SUBJECT : Hyundai ImageQuest Co., Ltd.
FCC ID: PJIL19C0D072
Class II Permissive Change
Orig. Grant Date: September 16, 2004

Transmitted herewith, on behalf of Hyundai ImageQuest Co., Ltd. is an application for a Class II Permissive Change Certification of the following 19-inch LCD Monitor:

FCC ID : PJIL19C0D072
Model No. / Type No.: Q90U / L19C0D072

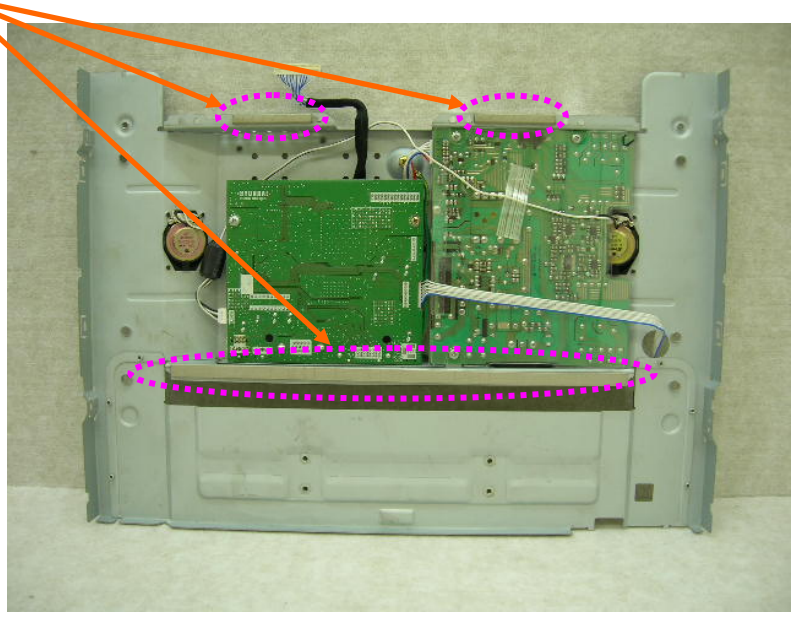
1.Attach a gasket on the main frame to contact the lcd panel.

2.Apply a ferriye core to the speaker cable.
